Meeting Agenda

Metropolitan King County Council

1:30 PM **Tuesday, February 3, 2026** **Hybrid Meeting**

Figure 2-1. Retail Service Area and Adjacent Purveyors

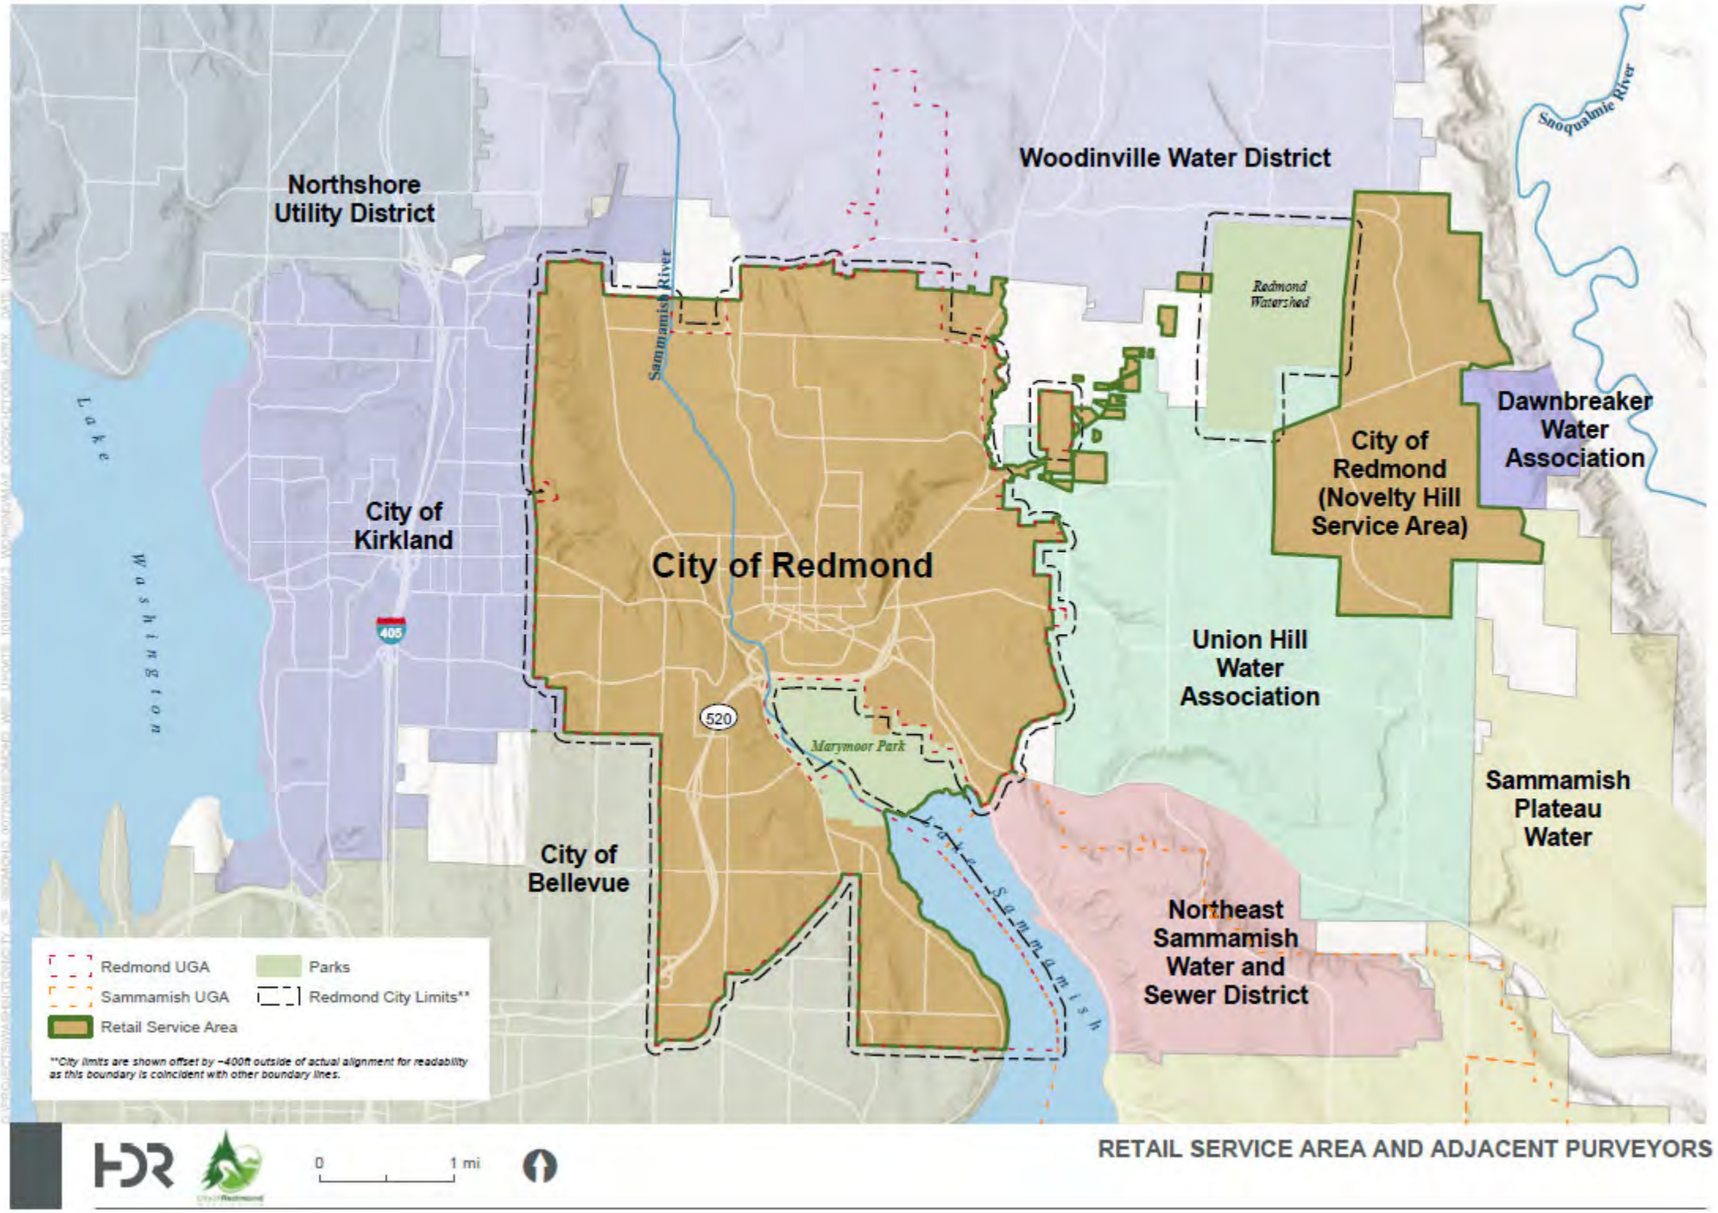
6	Section 2.2.1. Novelty Hill Service Area. While Figure 2-1 shows that the Novelty Hill Service Area is not contiguous/detached from other City service areas, the text does not explain why the City was the most appropriate water purveyor to provide water service to the residential developments in unincorporated King County. It would be beneficial to clarify when and why the City expanded its service area to service these developments. This explanation may justify the irregular service area boundary.	Text added to section 2.2.1 to broadly describe the history.
7	Section 2.3.1. 2016 King County Comprehensive Plan. The text provides a detailed description of the County's Comprehensive Plan policies and identifies adopted land use designations on Figure 2-3., however, it is appropriate to also provide the acreage associated with each land use designation and identify the development status of the acreage (i.e., vacant, developed, underdeveloped).	A new table (Table 2-1 has been added with this information.

8	Section 2.3.1. 2016 King County Comprehensive Plan. In review of Figure 2-1, it appears the City's service area encompasses unincorporated areas beyond the Novelty Hill Service area; however, the text doesn't appear to acknowledge this. While there is reference to the UGA, does the City's service area include any unincorporated Rural areas? It appears that Figure 2-3 shows a small portion of the service area being designated Rural area. Please clarify.	Yes, small portions of the RSA to the east and northeast serve rural unincorporated King County. Text was added in section 2.4.1 (Retail Service Area Boundaries) to further describe these areas within the RSA in unincorporated King County, and that policy UT-4 in the City's comprehensive plan described how rural water service will be provided.

5) Figure 2-1. Retail Service Area and Adjacent Purveyors. It is difficult to identify the Retail Service Area as the UGA and City Limits overlap with it. Can the map key be revised to identify the Retail Service Area more clearly in conjunction with other map attributes?

6) Section 2.2.1. Novelty Hill Service Area. While Figure 2-1 shows that the Novelty Hill Service Area is not contiguous/detached from other City service areas, the text does not explain why the City was the most appropriate water purveyor to provide water service to the residential developments in unincorporated King County. It would be beneficial to clarify when and why the City expanded its

8) Section 2.3.1. 2016 King County Comprehensive Plan. In review of Figure 2-1, it appears the City's service area encompasses unincorporated areas beyond the Novelty Hill Service area; however, the text doesn't appear to acknowledge this. While there is reference to the UGA, does the City's service area include any unincorporated Rural areas? It appears that Figure 2-3 shows a small portion of the service area being designated Rural area. Please clarify.

11) Section 2.4.1 Retail Service Area Boundaries. The text states that the City doesn't anticipate any major changes to its retail service area in the immediate future, however, the service area may be expanded to provide service to areas annexed into the City. While Figure 2-1 indicates that the unincorporated UGA adjacent to the City is not within the City's Retail Service Area, adding text to this section would clarify this situation. The text should also acknowledge that if the City expands its Retail Service Area, the water system plan would need to be amended to modify Figure 2-1 and update other appropriate text.

12) Section 2.4.1 Retail Service Area Boundaries. The text references an area that the City provides water service to that is not within and will not be included in its service area. The text references Figure 2-1 to identify the location of this area, however, in review of the figure, it doesn't appear this area is identified. The text also references discussions with Union Hill Water District and Woodinville Water District for future service discussions. Is there a timeframe in which this issue will be resolved? Please clarify?

13) Section 4. Planning Data and Demand Forecast. The text states that Redmond retails water in two areas; the City Service Area and the Novelty Hill Service Area, however, in review of Figure 2-1, it appears that there are other unincorporated areas within the City's Retail Service Area, including the unincorporated area north of NE 116th in the proximately of 184th Ave. NE. Please clarify.

Comment No.	Comment	Response
1	Service Area Boundary: Please correct the City of Kirkland Retail Service Area boundary shown on Figure 2-1. Please see the encircled area on the attached Kirkland Existing Water System Map.	Figure has been revised per the comment.
2	South and North Rose Hill Ownership Percentages. Table 3-5, Page 3-35, shows Redmond's contractual ownership of the South and North Rose Hill Reservoirs as 21.5% and 29.2%, respectively. It appears these ownership percentages are from the 1993 Rose Hill Assumption Agreement. The 1997 Interlocal Operations and Maintenance Agreement, amended in 2005, shows that Redmond owns 29.4% of the Rose Hill South Reservoir and 34% of the North Rose Hill Reservoir. The percentage used to define the contractual storage available to the City of Redmond may affect the analyses and text contained in Chapters 10 and 12. Please see the highlighted portions of the attached Interlocal Operations and Maintenance Agreement.	Table 3-5 has been updated, and associated updates in other chapters have also been made.

Figure 2-3. King County Land Use in the Redmond Area

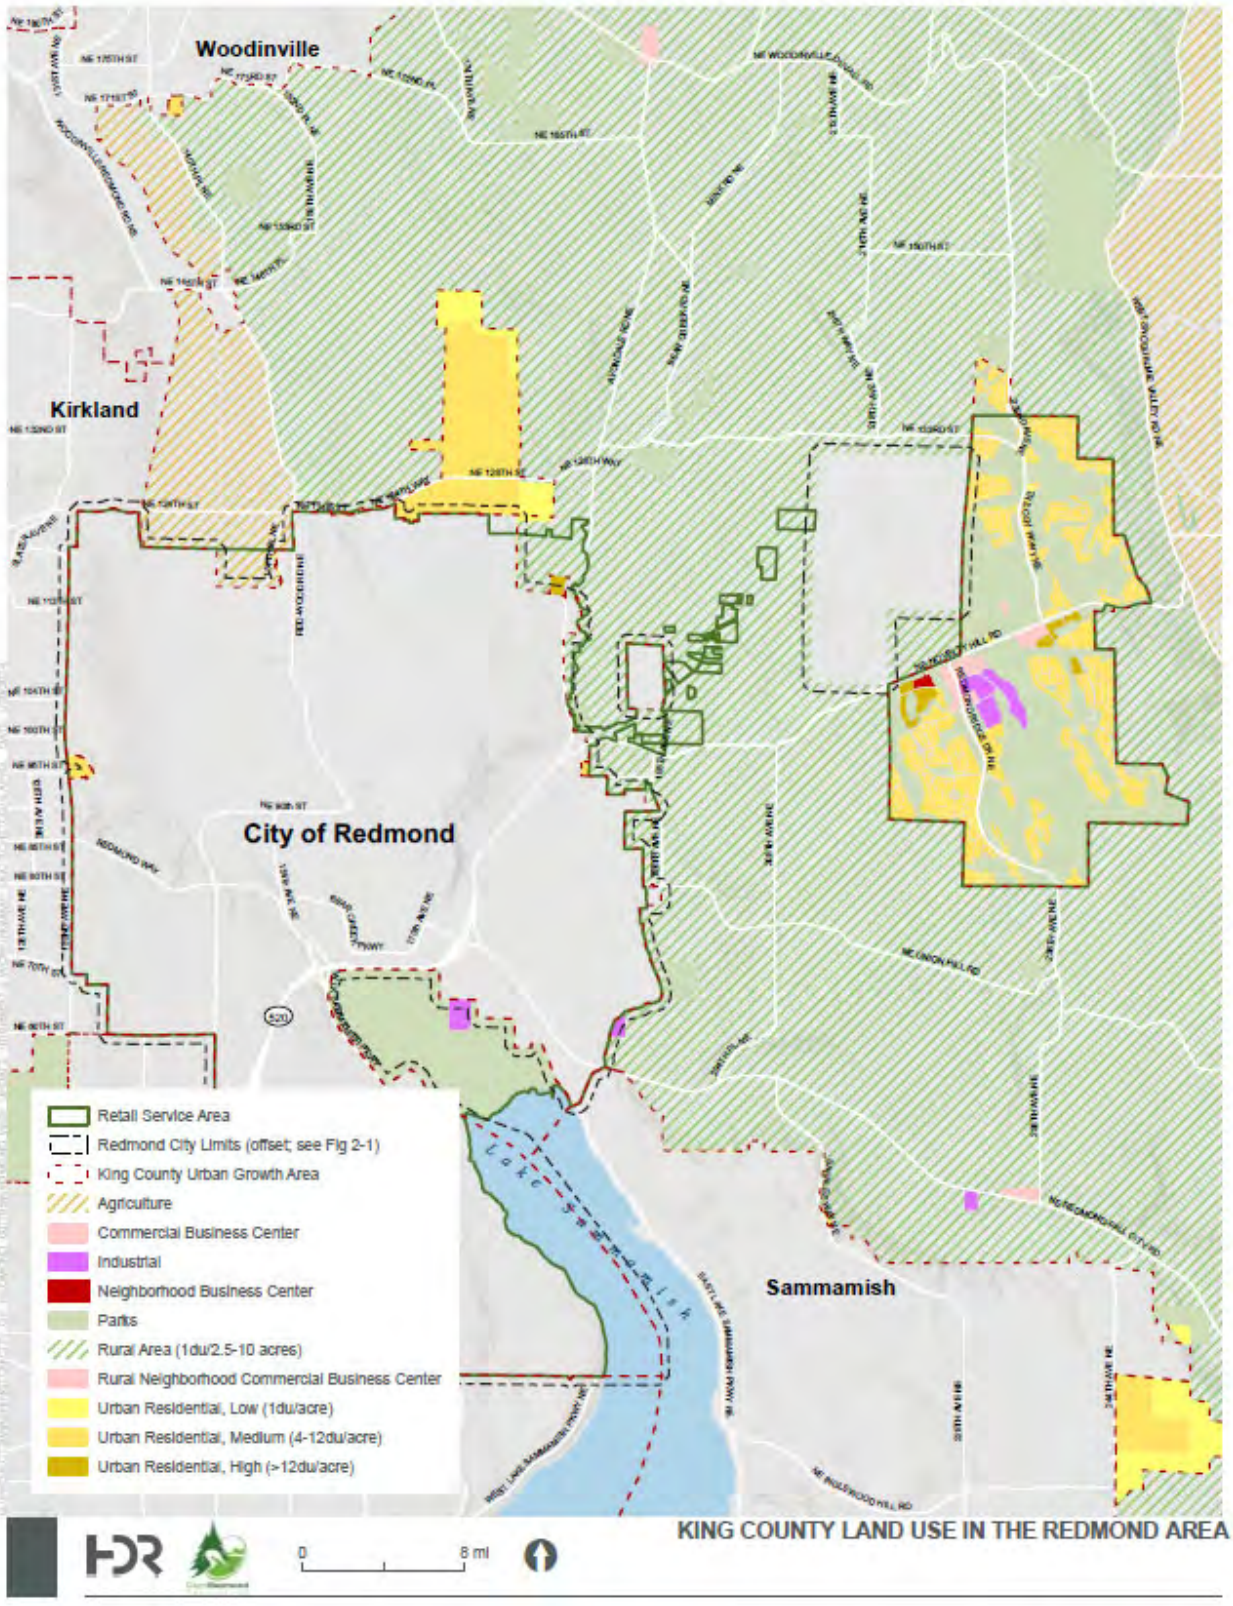
7) Section 2.3.1. 2016 King County Comprehensive Plan. The text provides a detailed description of the County's Comprehensive Plan policies and identifies adopted land use designations on Figure 2-3., however, it is appropriate to also provide the acreage associated with each land use designation and identify the development status of the acreage (i.e., vacant, developed, underdeveloped).

Figure 2-4. Redmond Comprehensive Land Use Plan

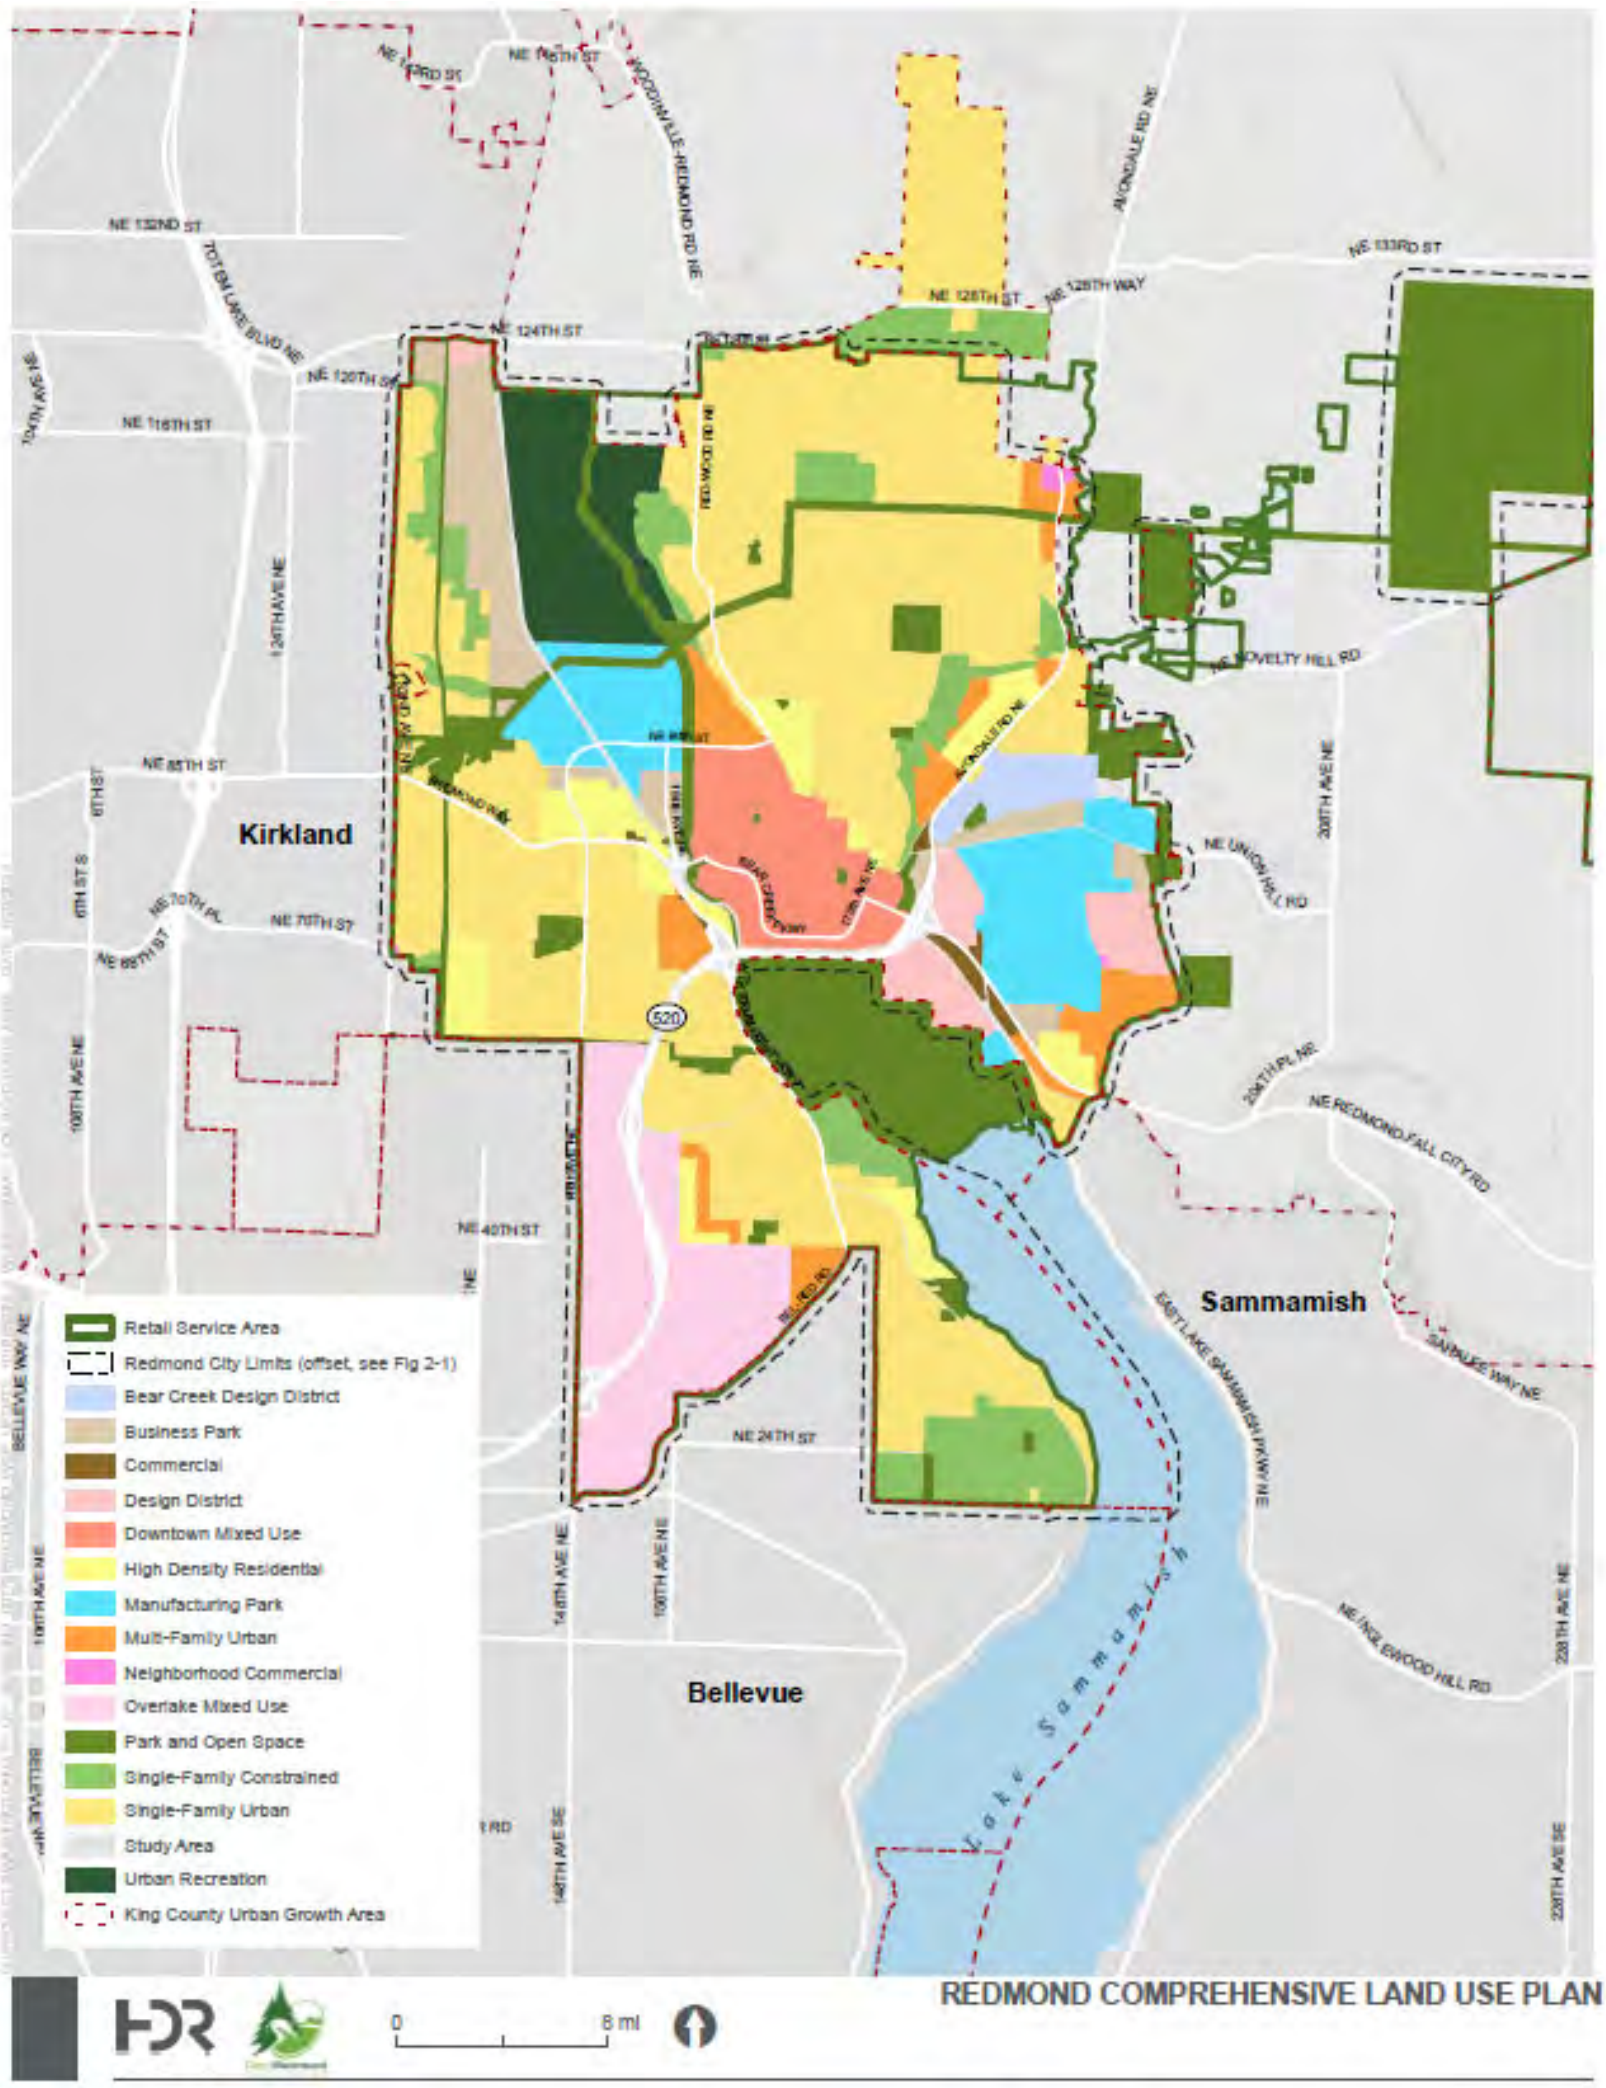
10) Figure 2-4 Redmond Comprehensive Land Use Plan. It is difficult to identify the Retail Service Area as the UGA and City Limits overlap with it. Can the map key be revised to identify the Retail Service Area more clearly in conjunction with other map attributes?

10	Figure 2-4 Redmond Comprehensive Land Use Plan. It is difficult to identify the Retail Service Area as the UGA and City Limits overlap with it. Can the map key be revised to identify the Retail Service Area more clearly in conjunction with other map attributes?	Figure revised, as noted in a previous response.
11	Section 2.4.1 Retail Service Area Boundaries. The text states that the City doesn't anticipate any major changes to its retail service area in the immediate future, however, the service area may be expanded to provide service to areas annexed into the City. While Figure 2-1 indicates that the unincorporated UGA adjacent to the City is not within the City's Retail Service Area, adding text to this section would clarify this situation. The text should also acknowledge that if the City expands its Retail Service Area, the water system plan would need to be amended to modify Figure 2-1 and update other appropriate text.	All the Redmond UGA that is not served by the City is already served by other purveyors. Added text to 2.4.1 indicating that the service area may be expanded to provide service to areas annexed into the City in the future <u>that are not currently served by another purveyor</u>. A statement was added that changes to the RSA would require a plan amendment and approval.
